[REDACTED]
Ofwat
Centre City Tower
7 Hill Street
Birmingham
B5 4UA

17th September 2022

[Creating tomorrow, together: consulting on our methodology for PR24 Bioresources Control - Appendix 4](#)

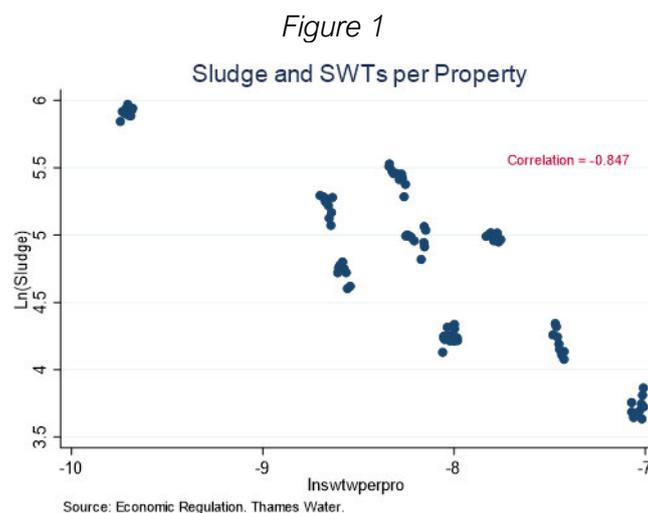
As mentioned in the supplementary paper for bioresources, we also noticed that there is a high correlation between *Sludge Produced and Sewage Treatment Works per property* as depicted in Figure 1 below (these two drivers are the only cost drivers in model BR2_O2). The negative correlation of -0.847 between these two drivers suggest that companies with the higher level of sludge tend to have fewer STWs per property. In other words, companies with large SWTs tend to exploit economies of scale. This STWs per property could be read as a measure of Sewage Treatment Works Density. In a model with *population density and STWs per property* these two drivers might be capturing similar effects. For example, it could be expected that the more population density a company face, the fewer STWs per property are needed in order to exploit economies of density.

With these levels of high correlation among regressors it is worth remembering the impact on the econometric models that these correlations could have on: *i)* coefficients with possible the “wrong” sign or implausible magnitudes or *ii)* coefficients might have high standard errors and low significance levels in addition to a high R², or *iii)* small changes in the data could produce wide

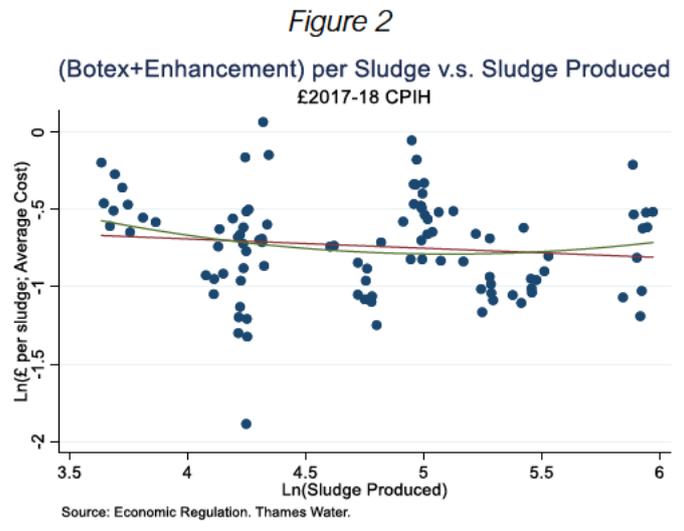
Turning now into an isolated relationship with the dependent variable, it is hard to see a significant correlation with Average Cost/Unit Price/£ per Sludge and the Total Sludge Produced as suggested in Figure 2. The within variation of sludge produced for each company is relatively low across time, with only marginal changes, whereas the between and within variation of companies' unit price is high.

Figure 2 does not suggest a strong relationship, making this driver potentially less relevant or problematic when estimating the UP models in a more extended version of the model, or that it might require a non-linear relationship which might bring other issues (e.g., degrees of freedom). The chart also suggests some potential significant outliers in the sample. Moreover, the estimated line of best fit for the average cost, plotted against volume of sludge produced, suggests a plain or flat-line, indicating that regardless of the volume treated through a range of technological processes, the average price seems to be broadly the same across the industry.

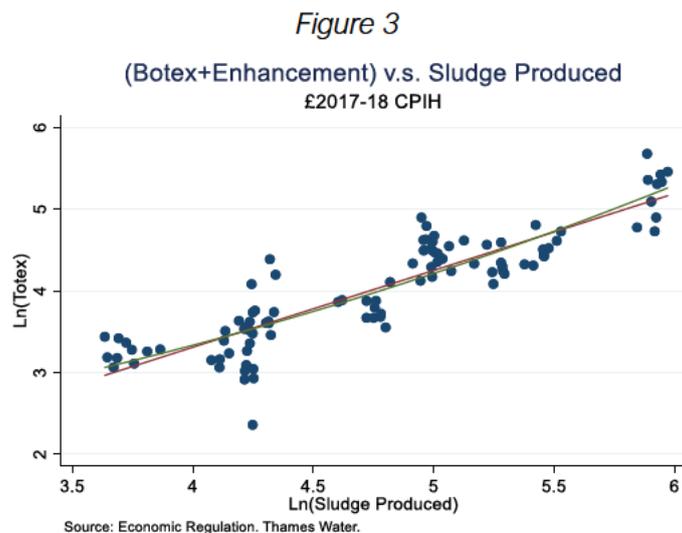
A different perspective is found when the depicted relationship is at the levels as Figure 3 illustrates. This relationship is reflected in models BR1_O2_L and BR2_O2_L in Table 2. Figure 3 suggests the level model approach of cost versus sludge produced should not be ruled out.

Figure 4

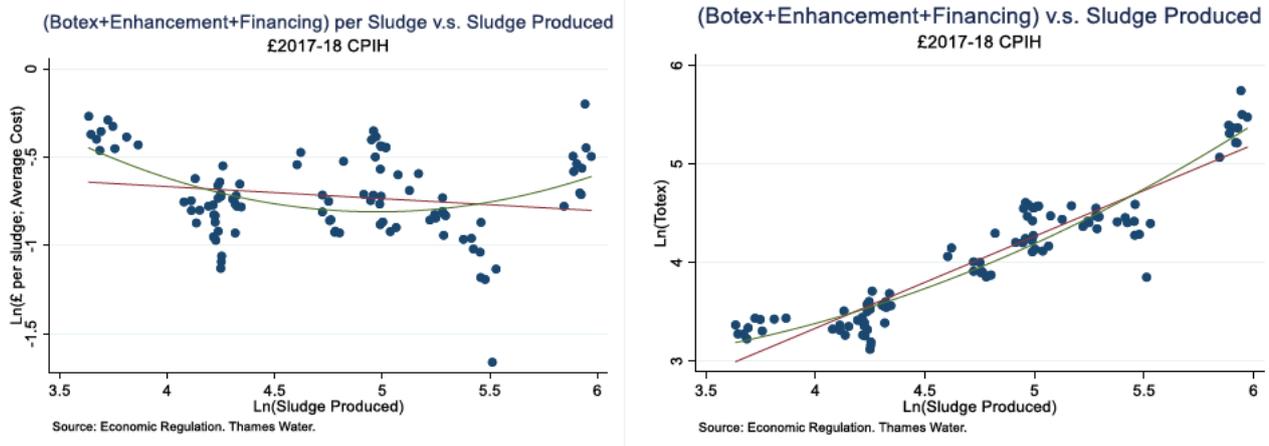
The last option presented in the paper, extends the previous definition of the dependent variable used in Option 2 to include financing costs. Figure 4 depicts the relationship with the UP and Level model options. The UP version could suggest a potential non-linear relationship with sludge produced when compared to the one presented in Figure 2. Using the levels seems to be similar to Figure 3.

Figure 5

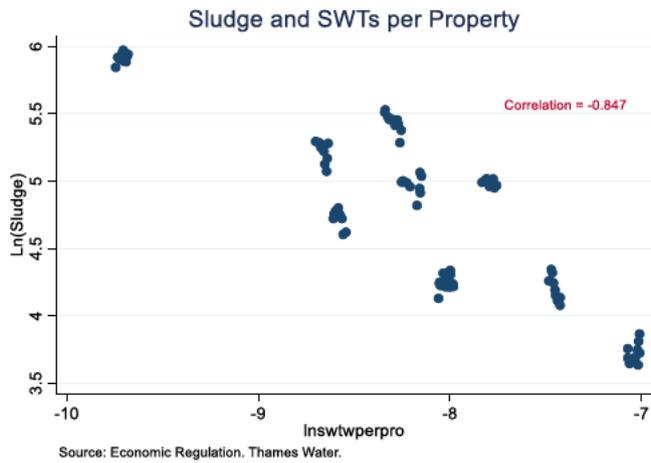
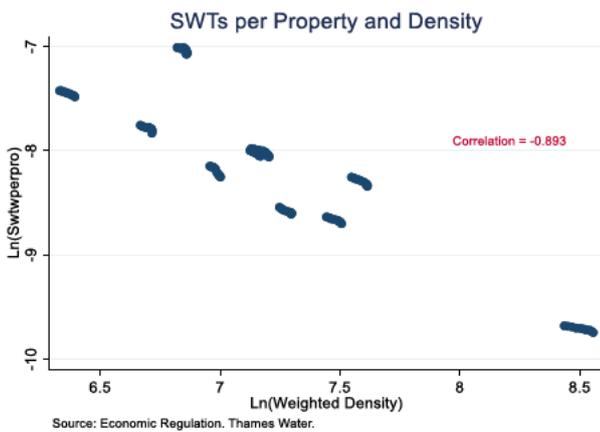
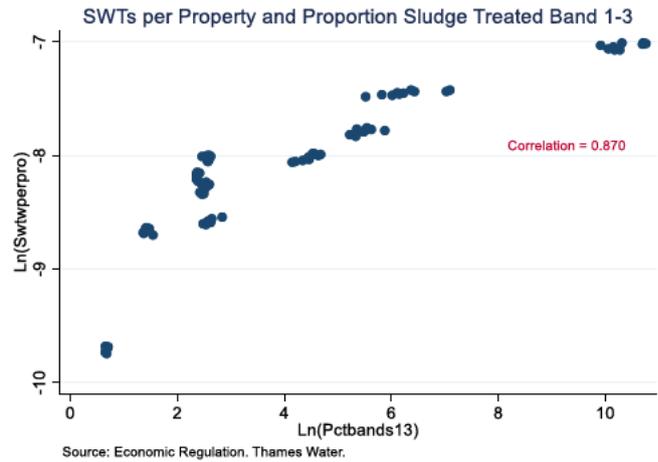
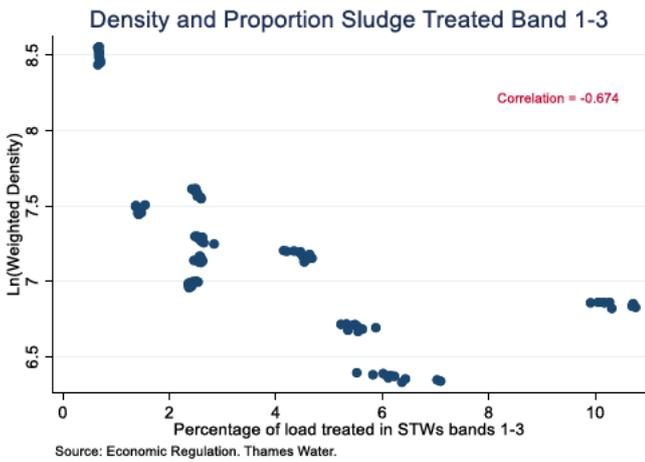
These correlations need to be considered carefully, to avoid the potential issues we highlighted previously when dealing with high levels of correlation among regressors, and in particular, when the sample size (N=companies) is quite small. Figure 5 illustrates these correlations for some of the cost drivers of the bioresources models. The illustrations show low levels of within variation for companies, something that could restrict the leverage in the estimation procedures. Sometimes it could look like a sample of 10 observations in some cases.
